STATE OF WASHINGTON
DEPARTMENT OF ECOLOGY

July 19, 2018

Re: Opinion on Proposed Cleanup of the following Site:

- **Site Name:** Stoneway Concrete Renton
- **Site Address:** 1915 Maple Valley Hwy, Renton, WA 98055
- **Facility/Site No.:** 62244377
- **VCP Project No.:** NW1702
- **Cleanup Site No.:** 2121

FIGURE 1

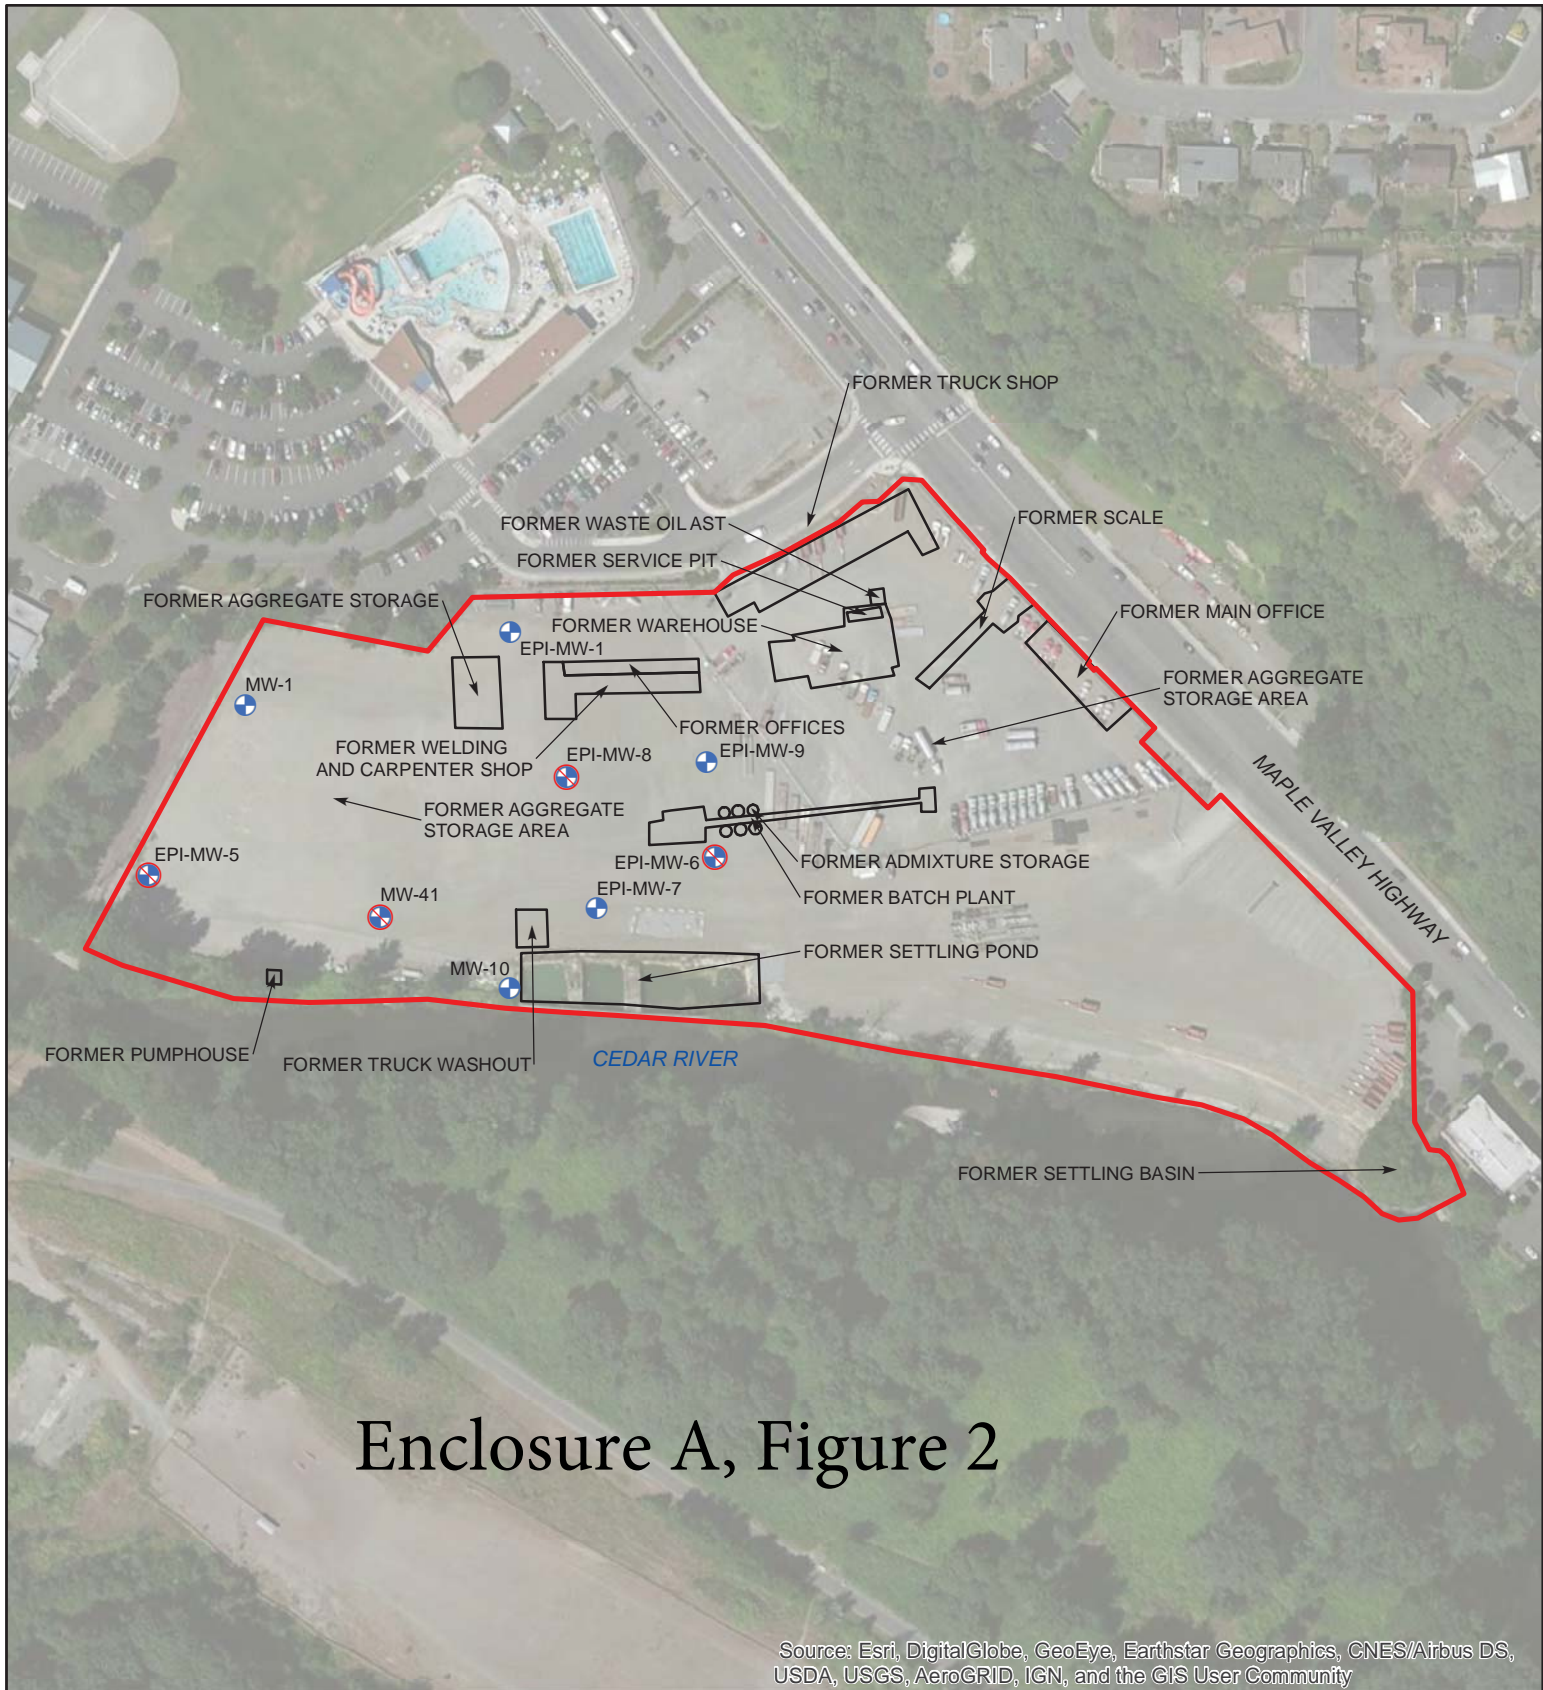
Site: Stoneway Concrete is located on King County parcel 1723059026 (the Property), which occupies 12.54 acres situated between the Cedar River and SE Maple Valley Highway (**Figure 1**). The Site boundaries generally follow the Property boundaries.

FIGURE 2
SITE PLAN
OLD STONEWAY CONCRETE SITE
1915 SOUTHEAST MAPLE VALLEY HIGHWAY
RENTON, WASHINGTON

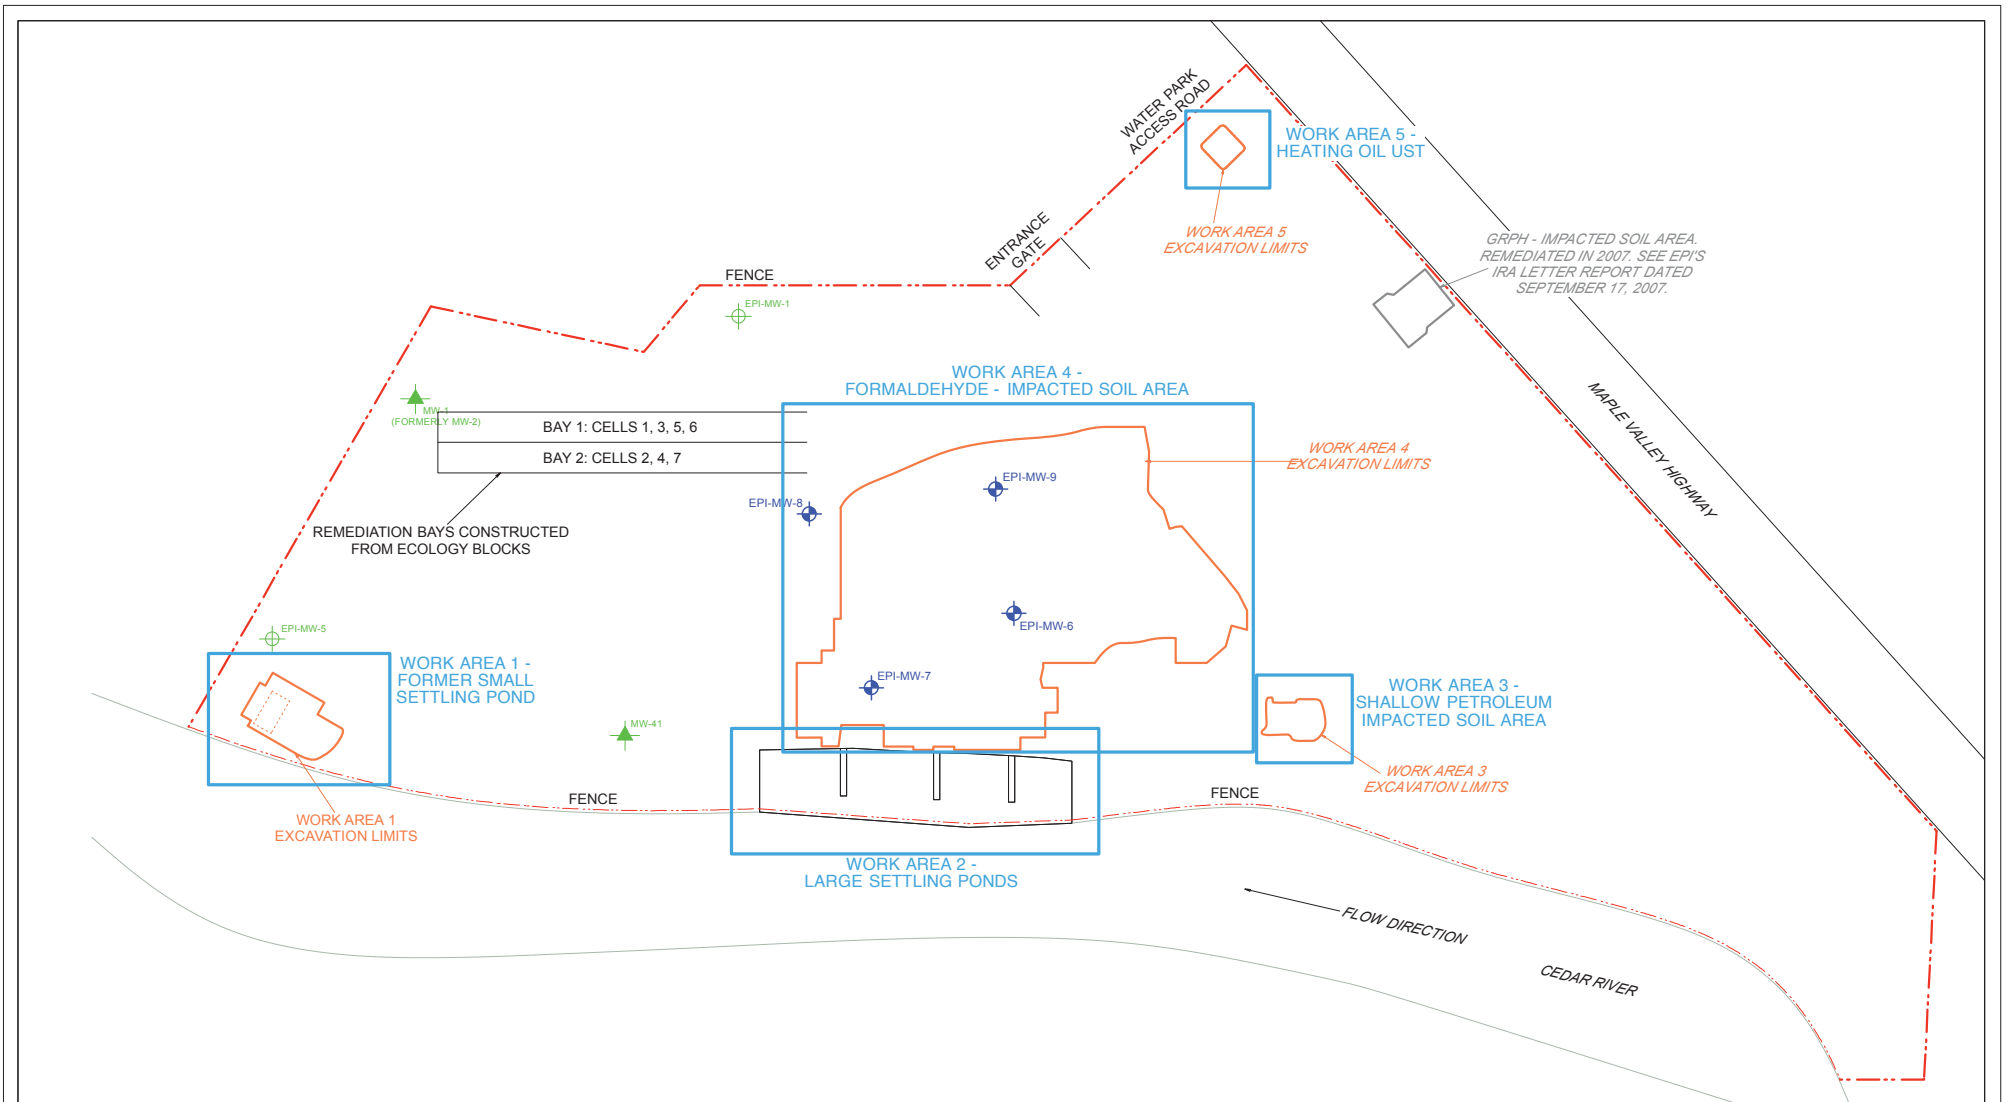
The Property was most recently occupied by a concrete batch plant, along with associated support activities (**Figure 2**). Operations on the Property ceased prior to October 2002 in order to conform with the City of Renton aquifer protection ordinance, which precludes industrial activities that use, handle, or store hazardous substances in Aquifer Protection Area Zone 1.
